# ePIC Jan. 2026 Coll. Meeting - CALOROC Workfest/BHCal

Murad Sarsour for BHCal  
Georgia State University

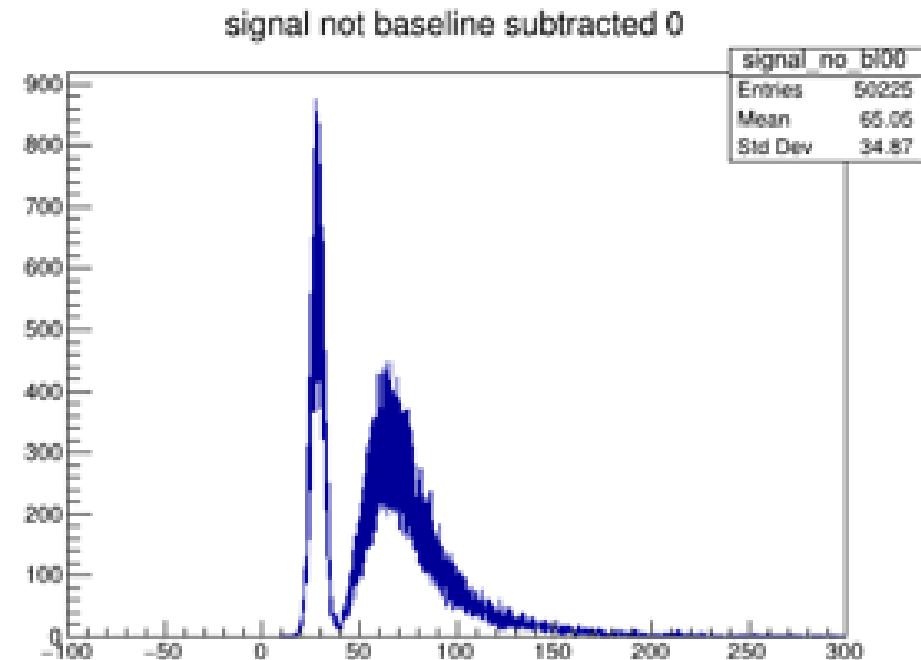
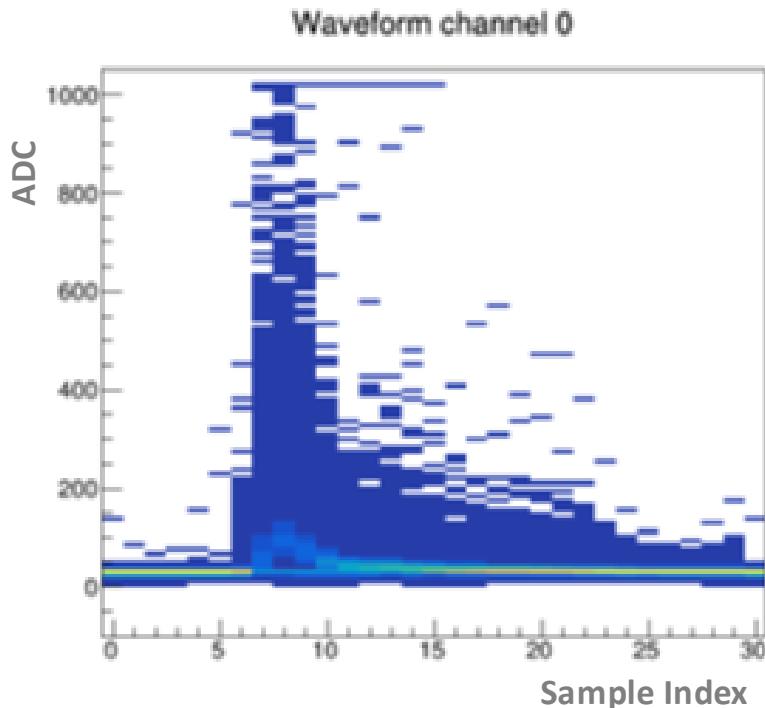
4. Do you have a measurement with certain settings of MIP peak, other fixed signal?  
(With the H2GCROC and settings)

Cosmic data for the 4-tile stack + Hamamatsu-S14160-3015PS (3x3)+H2GCROC.  
Integrate over channels 6 through 10. Not baseline-corrected data.
